Access Compliance Report Public Rights-of-Way (Curb Ramps)

Intersection ID: 10032867 Main Street: NATIONS FORD RD Cross Street: N/A Location: SW Initial Pass/Fail: Fail **Overall Compliance: No** Severity Score: 46.25 ADA ID: 6891D893425A Ramp Type: PerpDiag

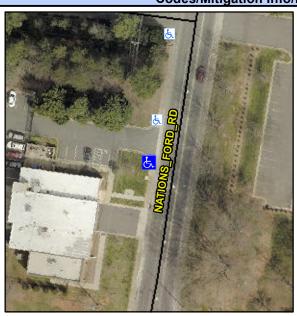
Possible Solutions: Remove & Replace Curb Ramp With Two New Directional Ramps or Equivalent. Surveyor Notes: N/A PROW/ADA: Not Found, R304.5.1, R304.2.2, R304.5.3

Compliance Description Data Compliance Description Data No N/A Ramp Length (in) 58.0 Ramp Slope (%) 13.1 No Ramp XSlope (%) No Ramp Width (in) 42.0 6.1 N/A N/A Flare Type LT N/A Flare Type RT N/A N/A N/A N/A Flare Slope RT (%) N/A Flare Slope LT (%) N/A Flare Traversable LT? N/A N/A Flare Traversable RT? N/A N/A N/A N/A **DWS Provided?** N/A Landing Length (in) N/A Landing Width (in) N/A N/A **DWS Contrast?** N/A N/A N/A N/A Landing Slope (%) DWS Length (in) N/A N/A Landing X Slope (%) N/A N/A DWS Full Width? N/A N/A Landing Curb? (Y/N) N/A N/A DWS Offset (in) N/A N/A N/A Shared Landing? N/A **Gutter Ponding?** N/A N/A Gutter Slope (%) N/A N/A Gutter Lip Ht (in) N/A N/A Gutter X Slope (%) N/A N/A Painted X Walk1? No N/A Painted X Walk2? No X Walk 1 Direction To E X Walk 2 Direction To N N/A N/A X Walk 1 Width (in) X Walk 2 Width (in) N/A X Walk 1 Slope (%) 5.6 X Walk 2 Slope (%) 1.9 X Walk 2 X Slope (%) X Walk 1 X Slope (%) 1.6 8.3 N/A N/A N/A Ramp inside XWalk2? N/A Ramp inside XWalk1? Road Slope (%) 5.2 N/A Clear Space? N/A N/A Road X Slope (%) 4.8 Clear Space to XWalk (in) N/A N/A N/A N/A Any Obstructions? Storm Grate/Utility Hazard? N/A **Obstruction Type** Storm Grate/Utility Type N/A N/A Yes Surface Condition? (G/P) Good
